ADDENDUM NO. 1 - OUTLINE AND SUMMARY INFORMATION

Project Name: Renne Library Northside Window Upgrades PPA No.: 22-0601
Location: Montana State University - Bozeman Date: April 1, 2026

LEVEL 3 DEMOLITION PLAN - NORTH

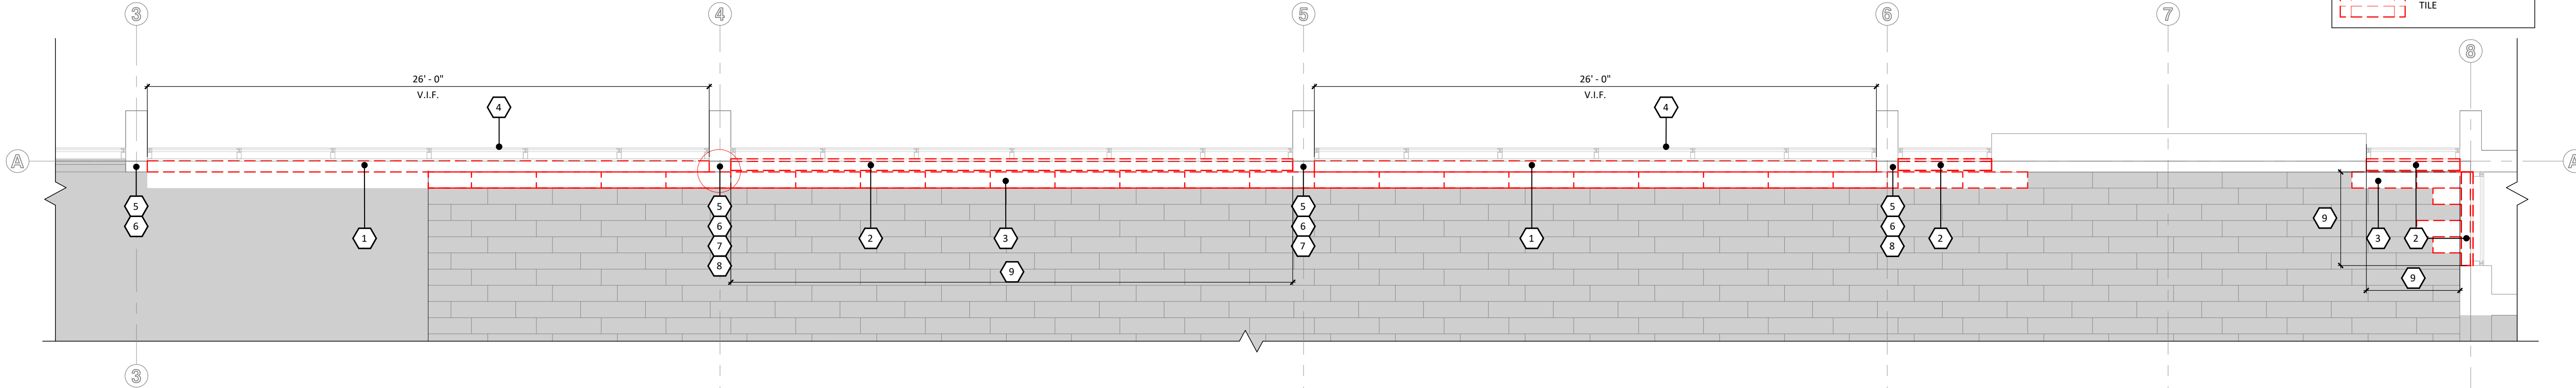
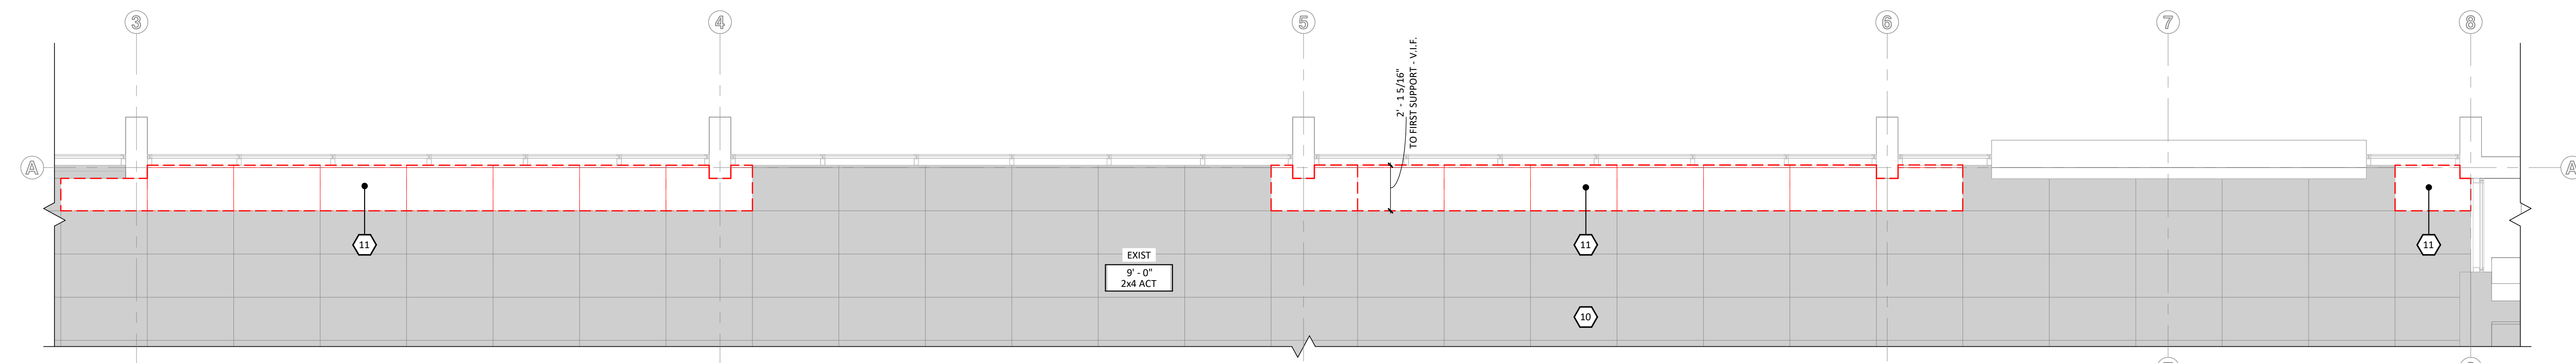
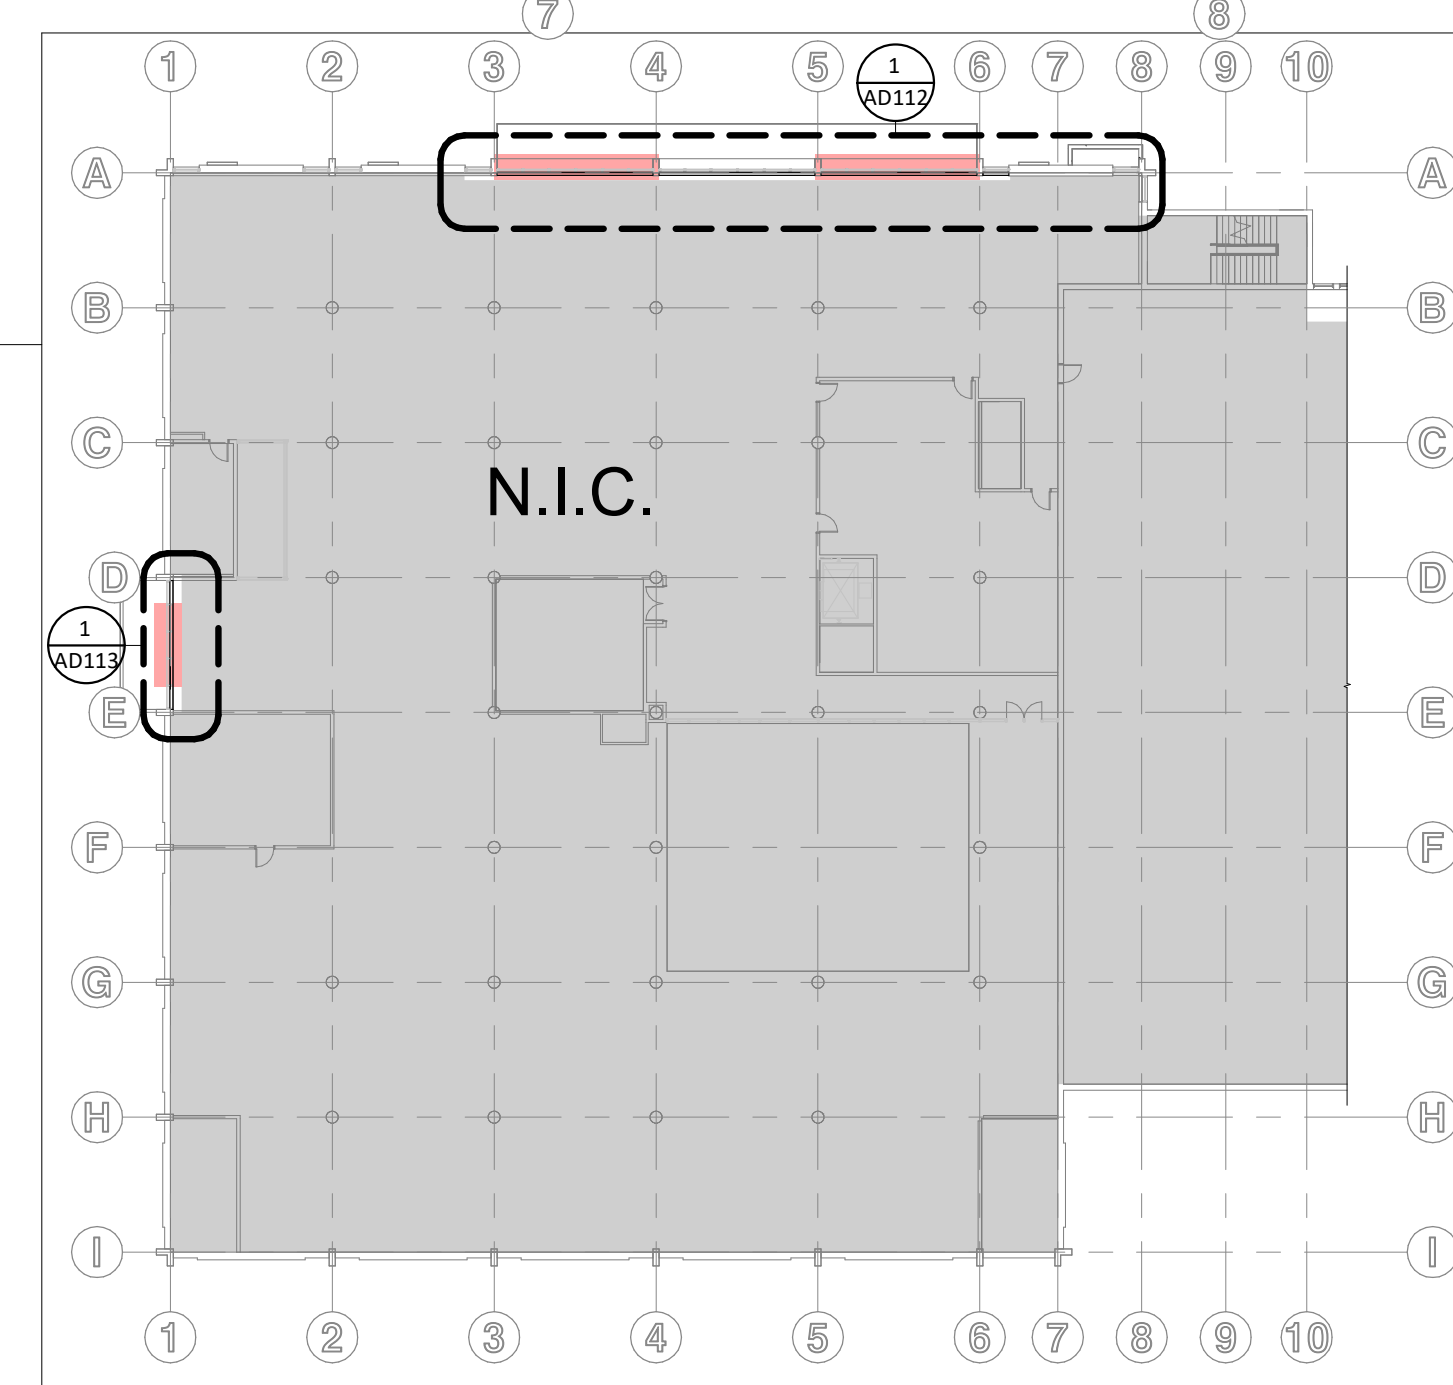
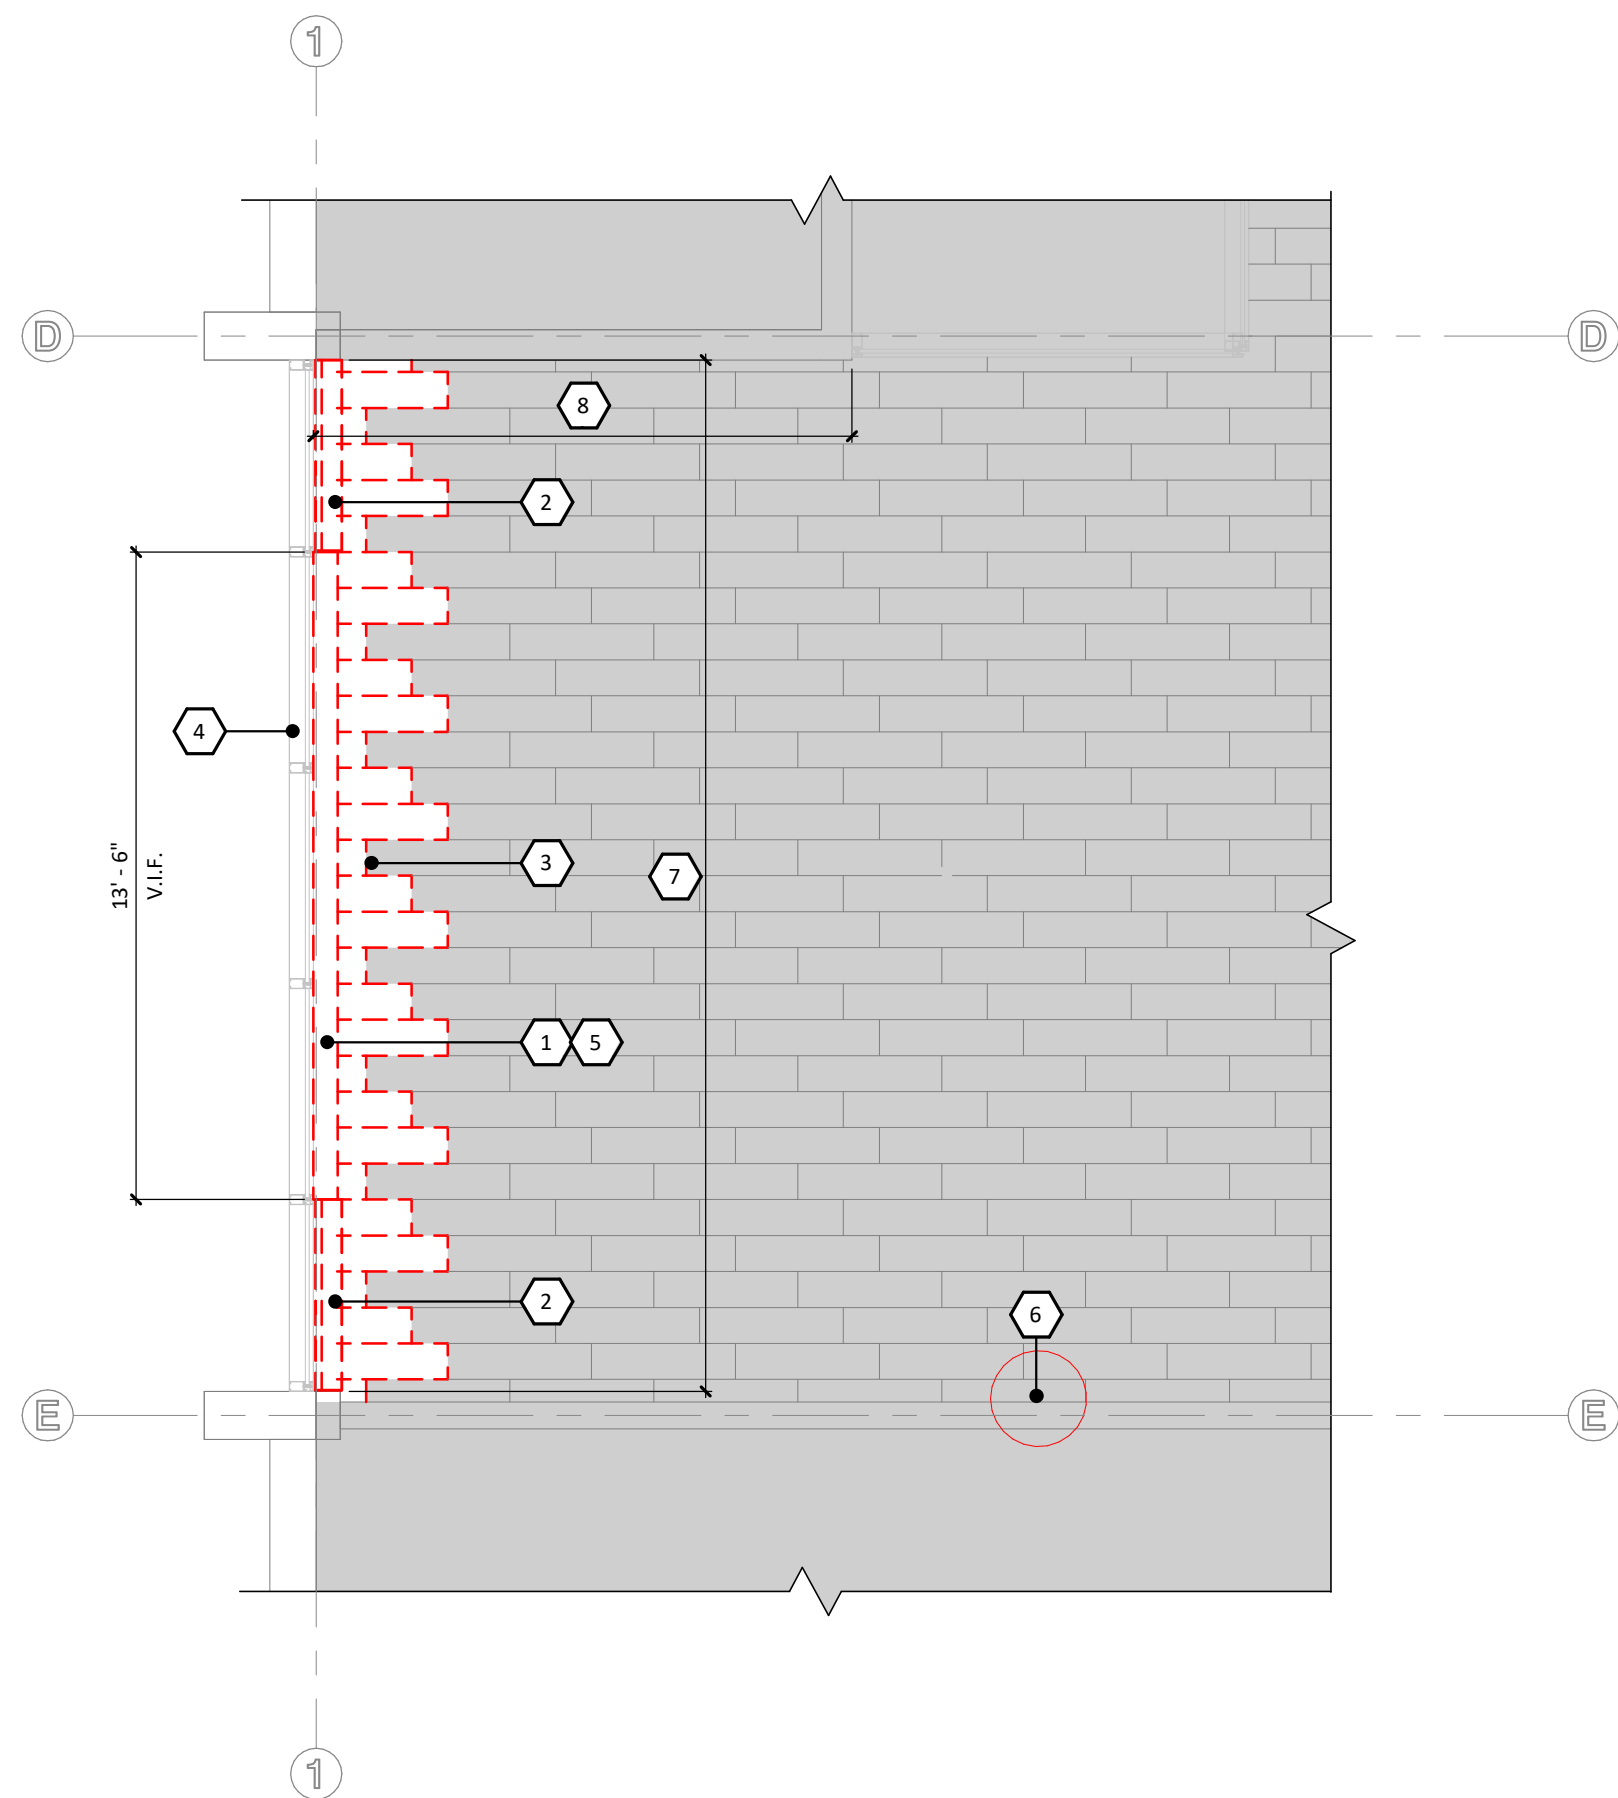
b. SHEET AD114 – DEMO KEYNOTES AD112 (NOTE 6):

- f. Sheet AD112 and AD114 note 5 states mortar is missing on the interior at columns in some locations. Verify soundness. Where unsound carefully grind out and prepare for new. Please confirm if GC is to hire structural engineer to confirm soundness and appropriate repairs.

CHANGE to: STAINING AT TOP OF CONCRETE COLUMNS AT ACT FRAME. CAREFULLY REMOVE ACT CEILING TILES AND FRAME AS

NECESSARY FOR FULL EXTENT OF CLEANING. CONTRACTOR TO REMOVE STAINING FROM COLUMNS WITHOUT DAMAGING EXISTING MATERIALS.

1. **Response:** Carefully remove any missing or loose mortar in areas where deterioration has occurred, excluding hairline cracks. Soundness refers to proper adhesion of the mortar to the column. This work shall be performed by a qualified mason. Approximately 100 square inches of mortar will need to be repaired. Contractor to field verify.
